# ADDENDUM NO. 2

**JACKSON ELEMENTARY SCHOOL RENOVATIONS**  
**Valparaiso, IN 46304**

**Addendum Two (AD.02)** to the drawings and specifications prepared by Gibraltar Design for **Jackson Elementary School Renovations** for Duneland School Corporation, Chesterton, Indiana.

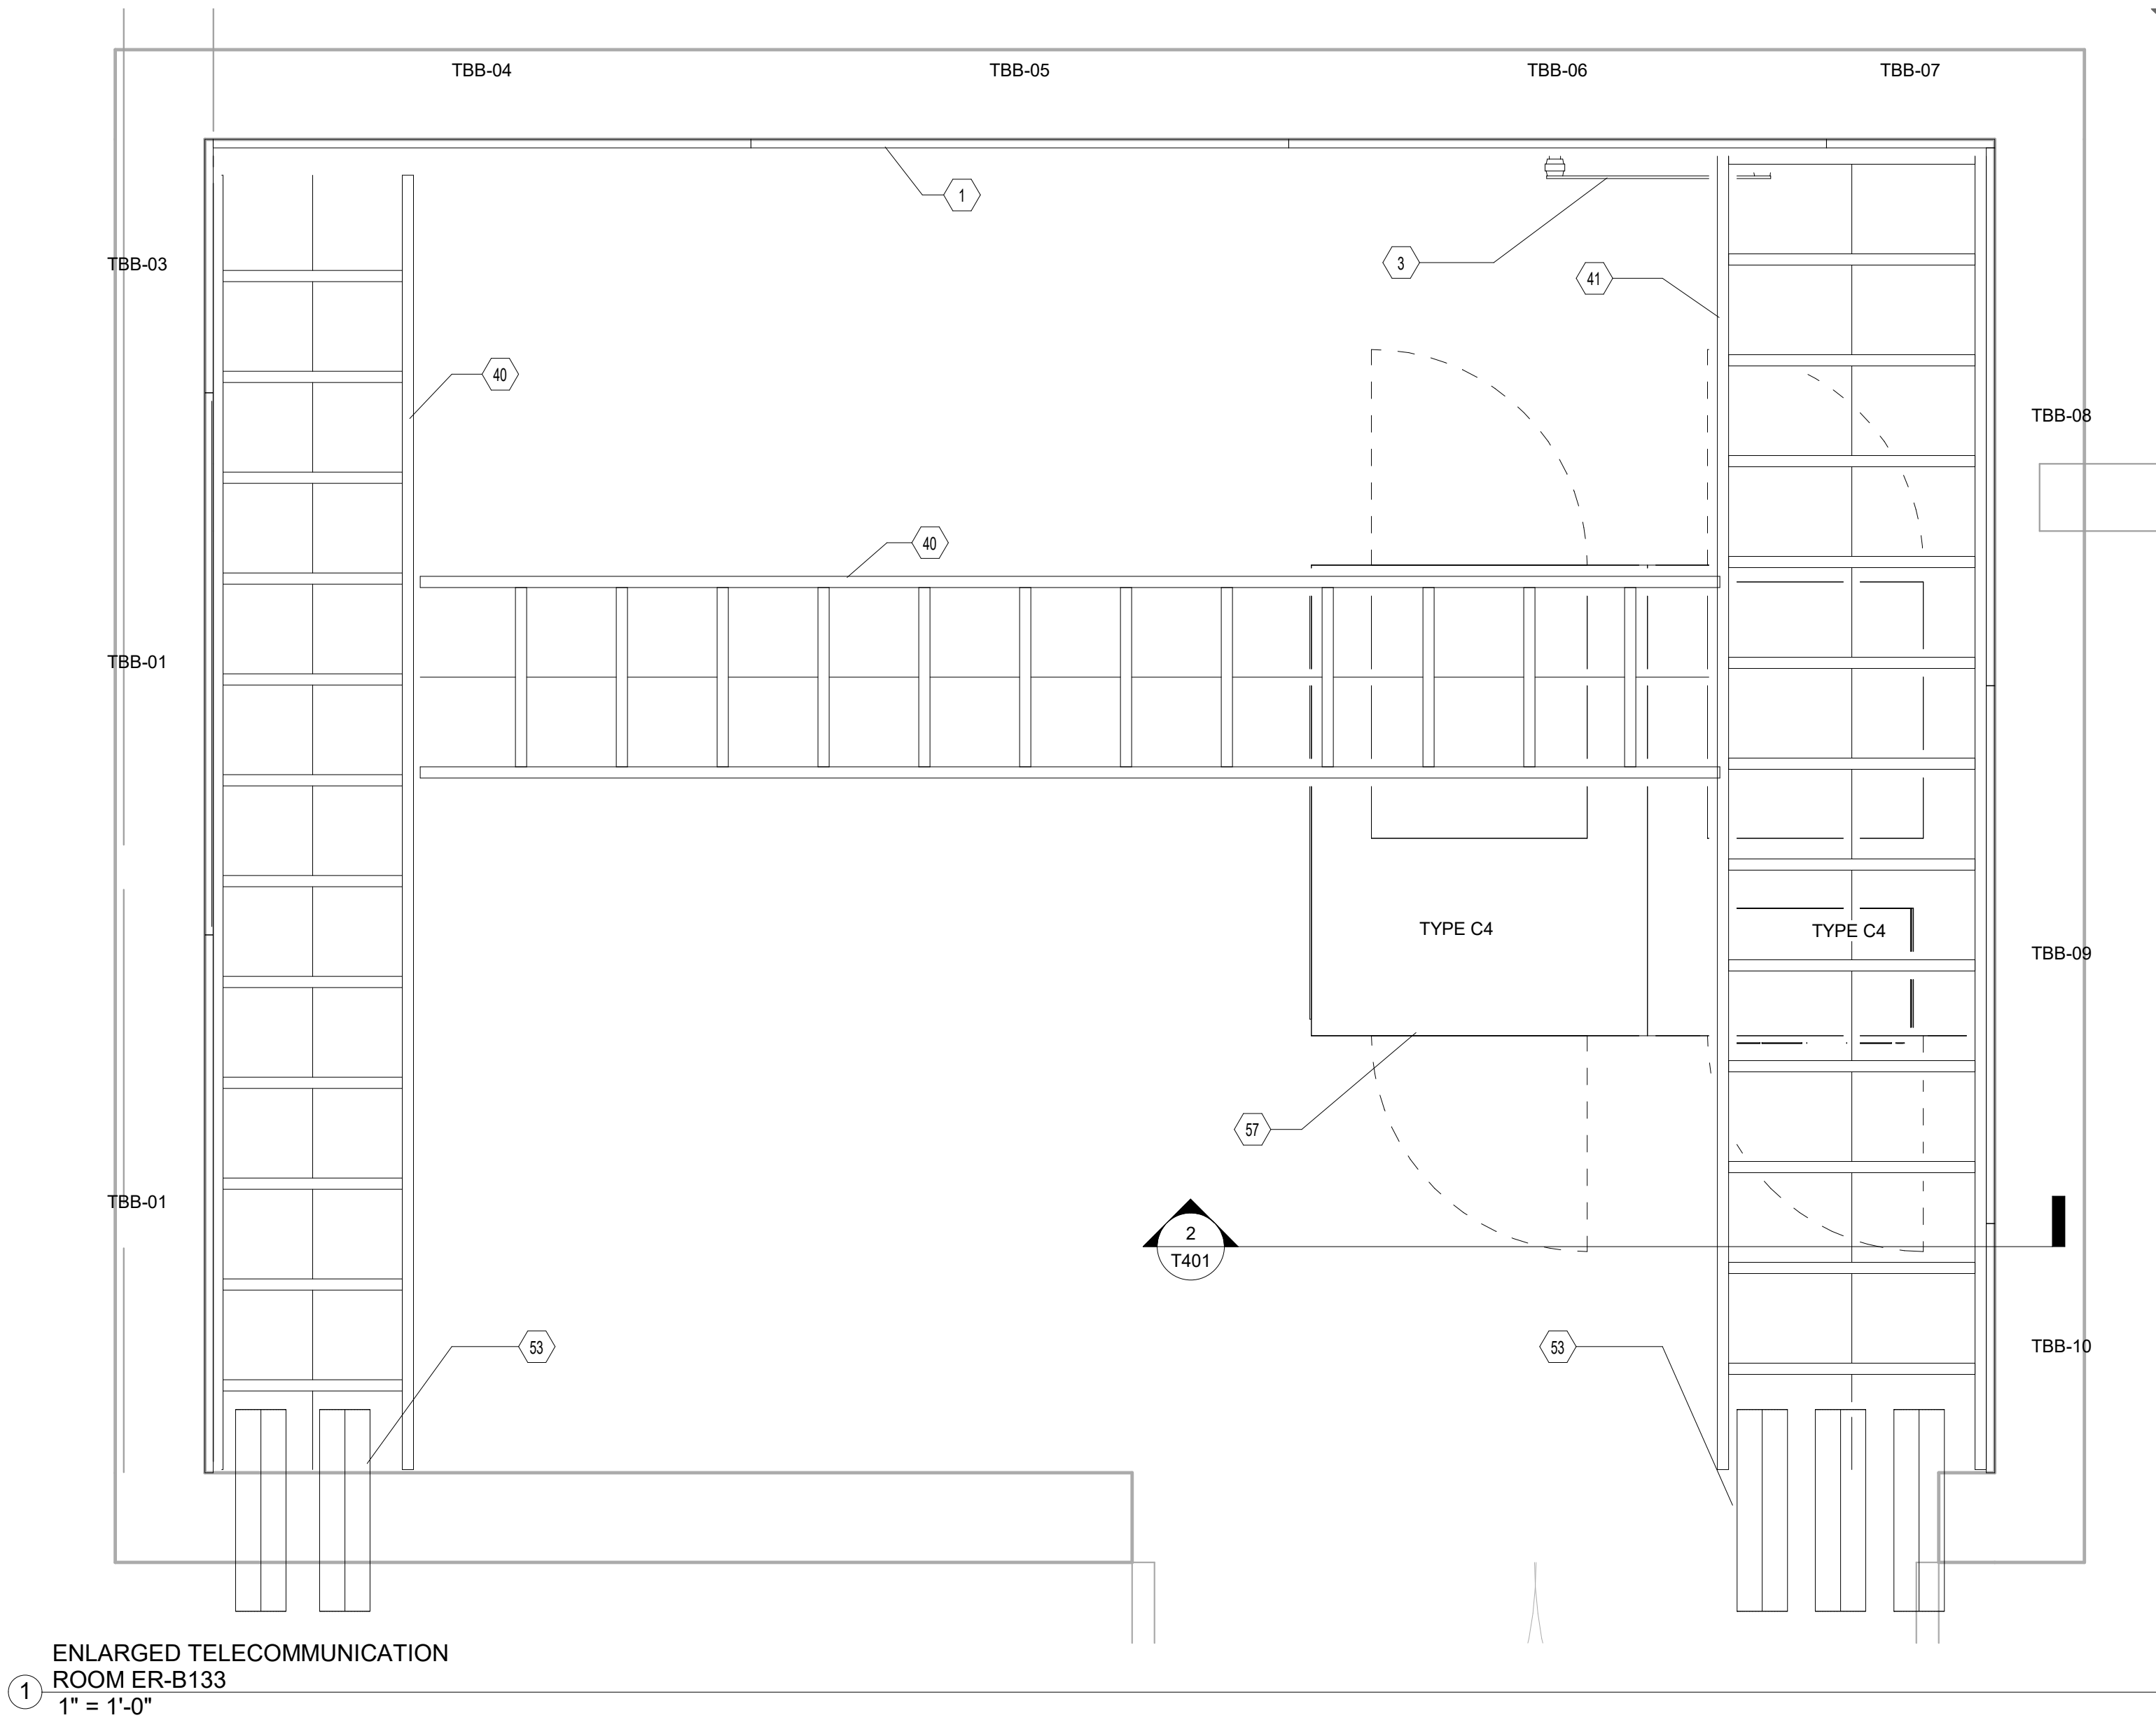
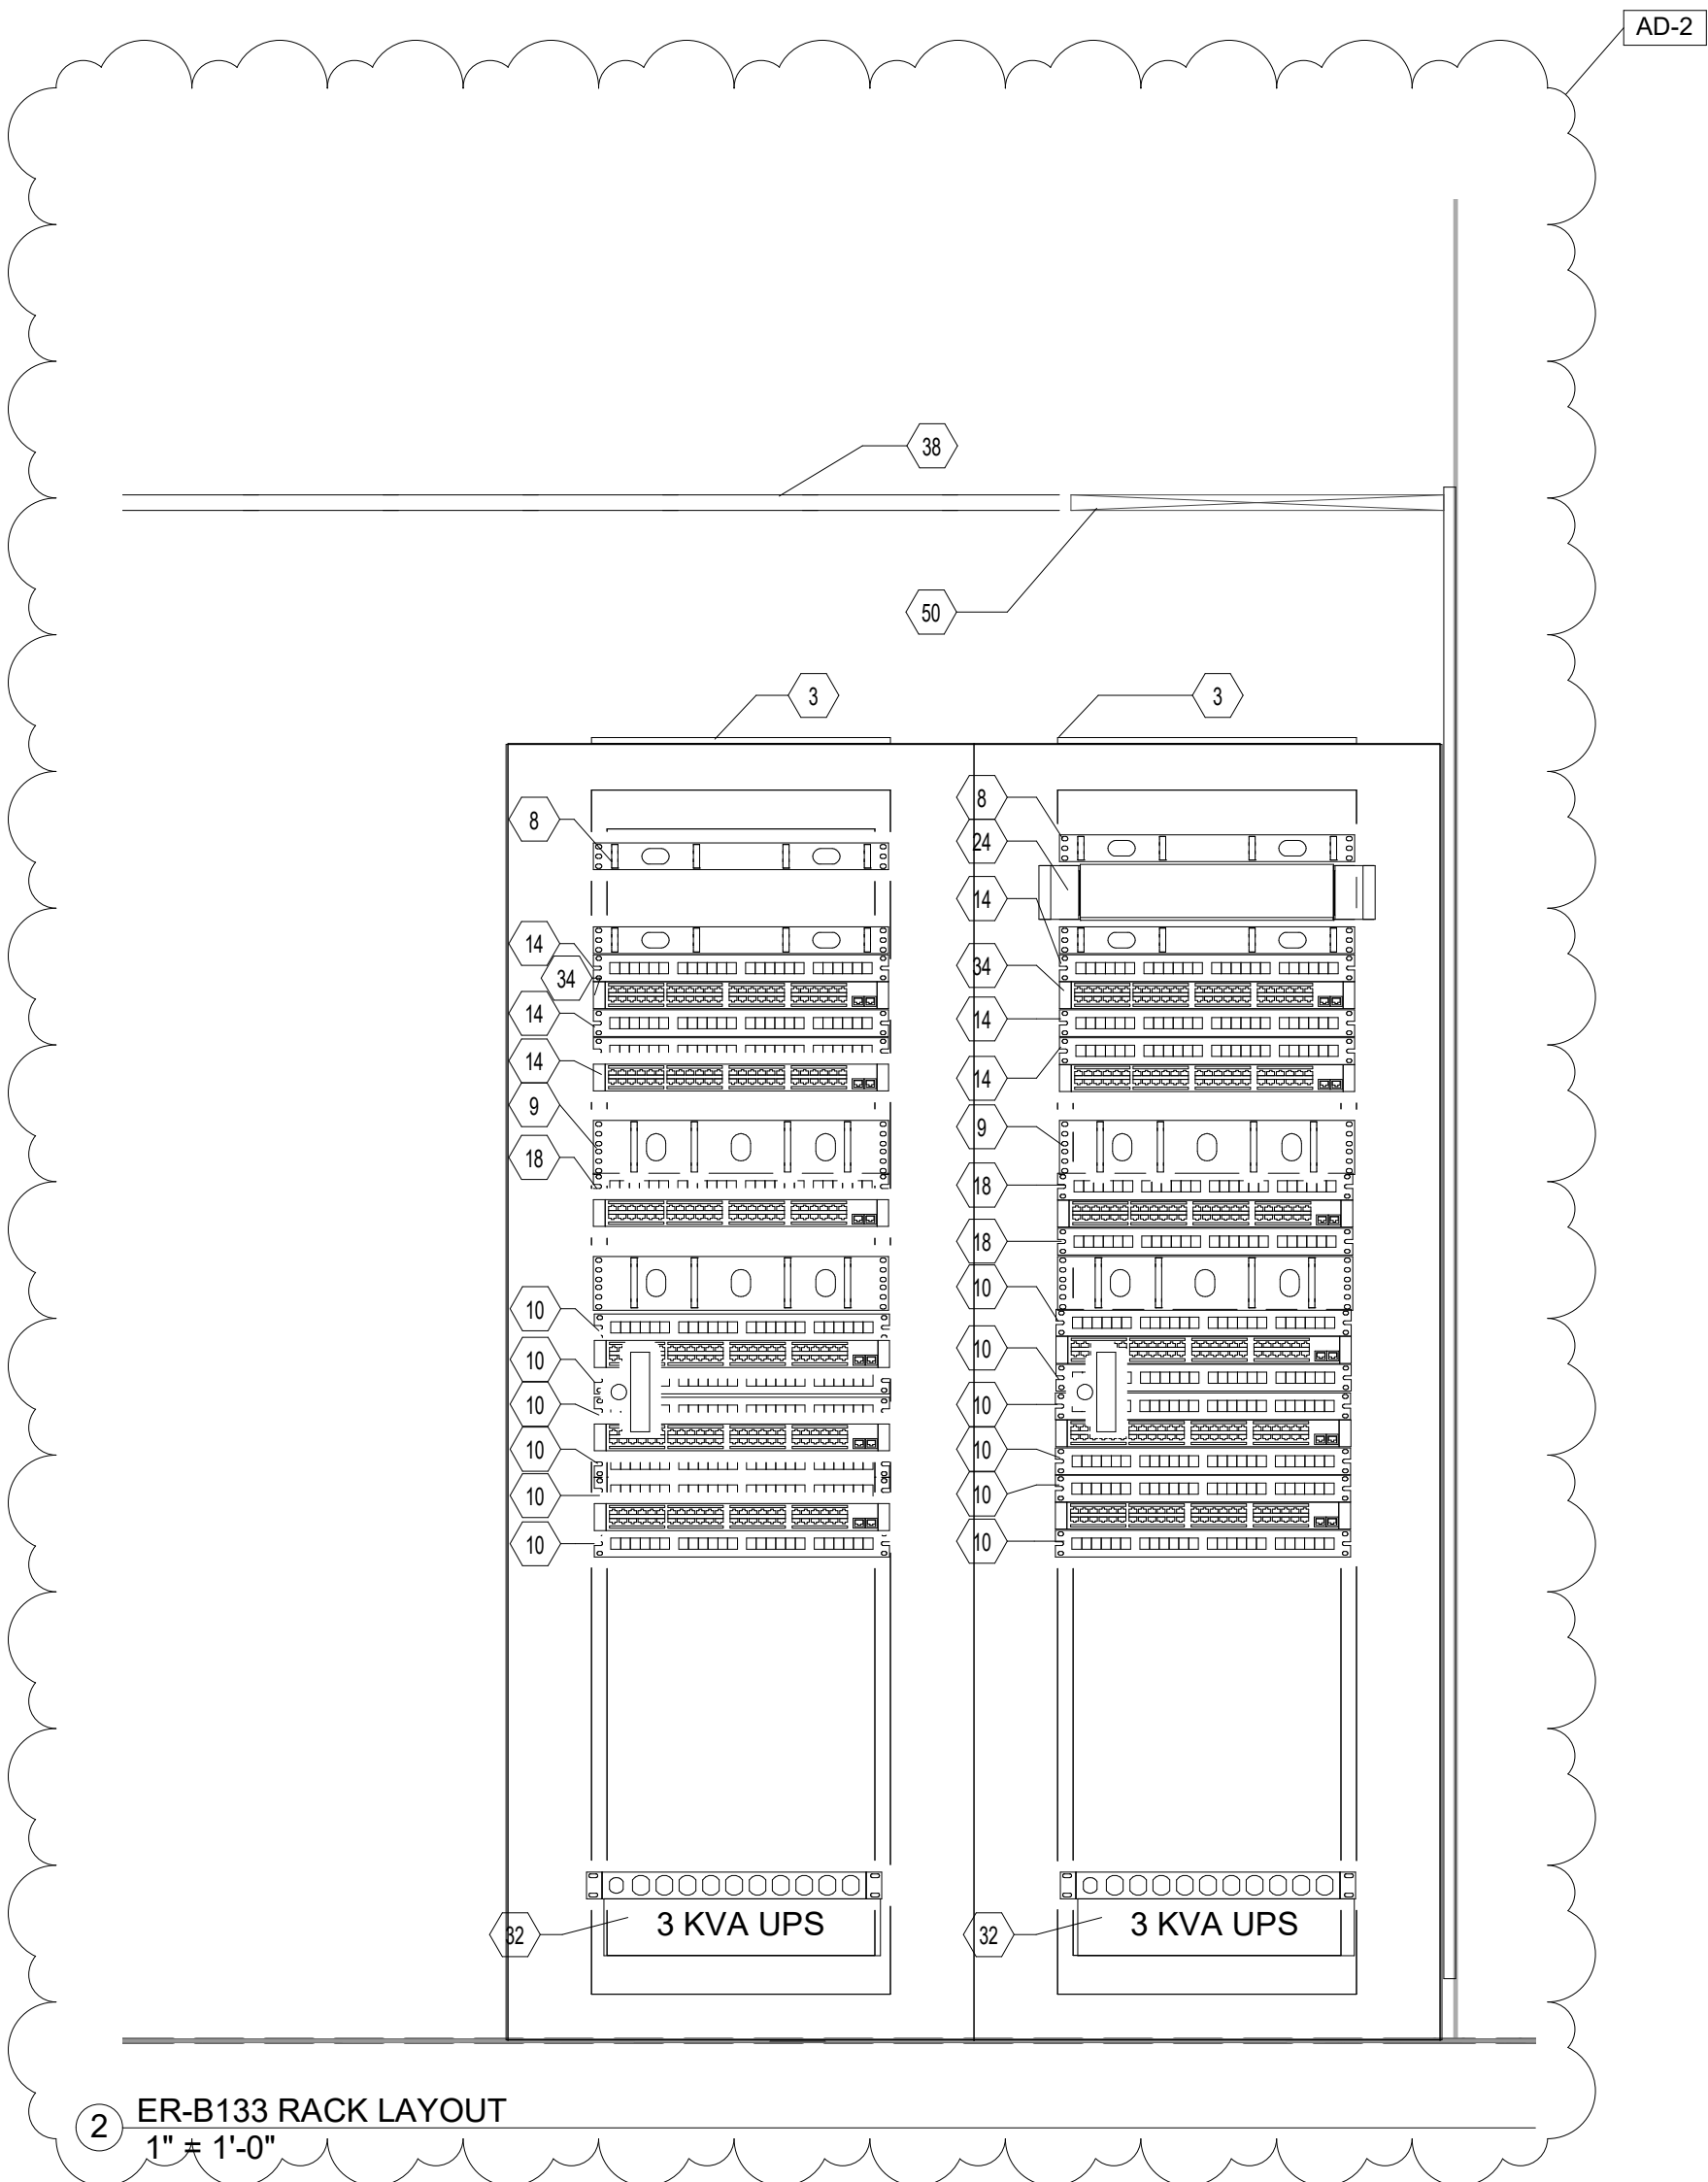
**14. Sheet T-401**

A. Refer to revised full size drawing, included in this Addendum, for updated rack diagram.
